**TM-1460
(SSC-N-349)
1100.500**

**Review of the Abort Dump Shown
in the SSC Conceptual Design Report***

**J.D. Cossairt
Fermi National Accelerator Laboratory
P.O. Box 500, Batavia, Illinois 60510**

April 1987

Figure 5.10-10. Abort system external beam dump. The abort dump is a passive sealed unit capable of withstanding indefinitely the 400 MJ of beam energy.

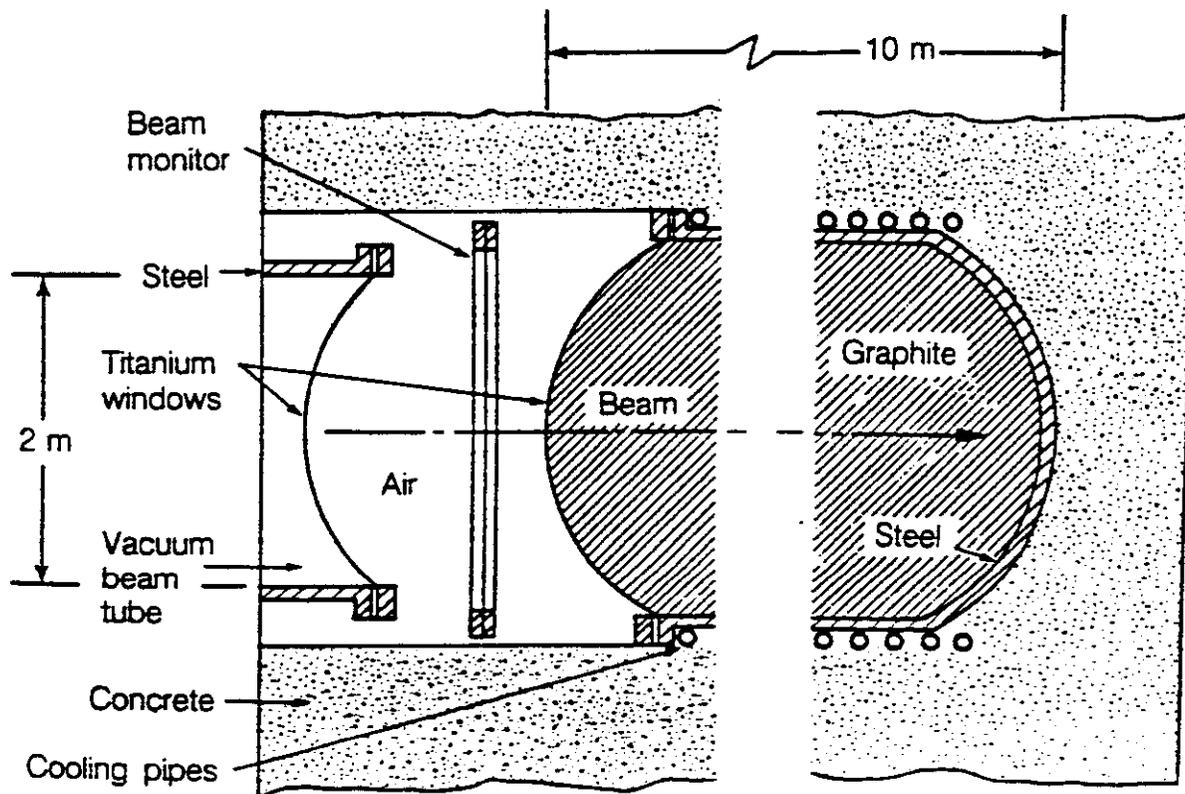
1. The dump is located about 1000 meters downstream of dispersing kickers and quadrupoles.
2. It consists of a graphite core surrounded by cooling water loops and concrete shielding.
3. It is about 10 absorption lengths long.
4. It is expected to absorb the 400 MJ due to the dump of 1.3×10^{14} 20 TeV protons perhaps as often as 500 times per year. Some aborts, of course, would occur at lower energy.

The first, and perhaps most essential, design concern is that this dump will not self-destruct! Following the CDR, the quads and the drift space spread the beam over an area of 0.5 m^2 and the shower is largely confined to a length of 3 m located 3 m deep in the shield. This can be checked, and found roughly to be true by looking at the report of Van Ginneken, et.al. (Fermilab FN-447(SSC-106), "Shielding Calculations for Multi-TeV Hadron Colliders") from which the following 3 figures have been copied.

For example it is clear that less than a few per cent of the energy is deposited more than 10 cm radially distant from the incident particle. 3 or 4 cm contains all but about 10 % of the beam. The peak is indeed reached in approximately 3 m and the total longitudinal extent is well described by 3 m. In fact, in my judgement, the crude approximation stated in the CDR is conservative. Thus one must agree with the statement that 1.5 m³ is involved in the initial energy deposition. I verified that the specific heat, C_h of graphite is 0.17 cal-g⁻¹ per °C which converts to the quoted value of 0.7 J g⁻¹ per °C. Absorbing one abort's worth of energy then results in a temperature rise:

The CDR stated a value of 600 °C/GJ which may have taken into account the variation in specific heat with temperature. For comparison, from the Fermilab Antiproton Source Design Report, I have copied the following graph of "enthalpy reserve" for several materials including graphite. It is clear that the above value of 120 J/g gives a comparable temperature rise on this curve as well. It is likewise clear that the transfer of heat to the rest of the dump or result in temperatures more than an order of magnitude lower. Even without water cooling this design appears to be adequate. It is especially fortunate that such a jolt of energy is possible only about once per 10 minutes. It appears that the water cooling serves most to reduce the pressure of the air contained within the dump volume.

To get an idea of the magnitude of this problem, I scaled dimensions directly from the first figure above. This found the water cooling loops to be at radius 130 cm. At the approximate pitch of 3.5 cm, and the "guesstimated" inside diameter of 1 cm the volume is approximately 1.8×10^5 ml, or about 50 gal. The one cm thick cylindrical shell containing the tubes has a volume of 8.2×10^5 ml over the 10 m long dump. So that ~20 % of the volume of this shell is occupied by water (assume no "bubbles"). Again, taking a figure from SSC-106 (copied below) we find a longitudinal integral of 18 stars/(cm*proton) in graphite at that radius.
